# Dart 18 Rule Changes August 2013

Changes to the class rules approved by the IDA at Carnac come into force as of 1st August 2013.

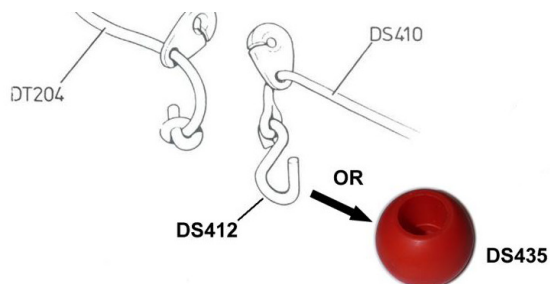
iii) Rule 9(c) was added to – DS412 and/or DS435 can be removed, as can the reaching line rope (DS410) and the reaching line shockcord (DT204) So you can remove the reaching line setup completely, sail with it as in the past or replace the hook with a plastic bobble

iv) Alternative down haul system approved with turning block DM371 (page 14) at one end as illustrated on page 33. Note that the new block DM371 is specified and cannot be replaced with similar blocks from another source. The block should be attached directly to the bracket at the bottom of the mast (DM348) without using a shackle. The top block (DM370) has also been modified with an optional extra turning sheave as on page 15.
